APPLICATION NO.	FILING DATE	FIRST NAMED INVENTOR	ATTORNEY DOCKET NO.	CONFIRMATION NO.
10/826,432	04/16/2004	David Allen Kastrup	140728	9853
29399 7590 05/21/2008 JOHN S. BEULICK (12729) C/O ARMSTRONG TEASDALE LLP ONE METROPOLITAN SQUARE SUITE 2600 ST. LOUIS, MO 63102-2740				
			EXAMINER NGUYEN, ANDREW H	
			ART UNIT 3746	PAPER NUMBER
			NOTIFICATION DATE 05/21/2008	DELIVERY MODE ELECTRONIC

Office Action Summary

DETAILED ACTION

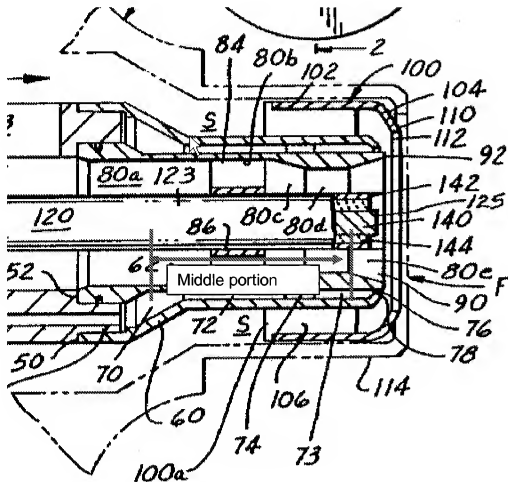
5. Claims 7-8, 13-15, and 18-20 are rejected under 35 U.S.C. 102(b) as being anticipated by US Patent 4,938,019 to Angell et al (Angell).

In reference to claim 7:

a venturi (62 – defined by Angell as "sleeve extension", but the venturi is included in the sleeve extension structure, i.e. the sleeve extension defines the venturi chambers, and thus, is considered a part of the venturi) comprising an upstream portion, a downstream portion and a middle portion (see definition of portions in Fig below) extending therebetween; and

a secondary swirler extending circumferentially around said venturi (100, 106, 60 – all parts of the secondary swirler), said secondary swirler coupled to said venturi (swirler 60 coupled to venturi 62 by wall 54) to substantially prevent fluid flow between a radially inner surface of said secondary swirler and a radially outer surface of said venturi at said upstream and downstream portions ("to substantially prevent ..." does not provide a clear limitation; how much is a "substantial" amount?), a gap is defined between said radially inner surface of said secondary swirler and said radially outer surface of said venturi middle portion (gaps 73, 72)

With regards to applicant's arguments for claims 7 and 14, that "Angell does not describe nor suggest a swirler coupled to the venturi to substantially prevent fluid flow ... wherein a gap is defined between the ... swirler and the ... venturi at a middle portion of the venturi", it is noted that Angell does teach a swirler coupled to the venturi (see rejections of claims 7 and 14 above). The phrase, "to substantially prevent fluid flow ..." is very general in nature and does not specifically present a limitation. It is not known what constitutes a "substantial" amount. It is further noted that Angell does teach a gap between the swirler and venturi that occurs at a middle portion of the venturi (see Fig from rejection of claim 7 above).
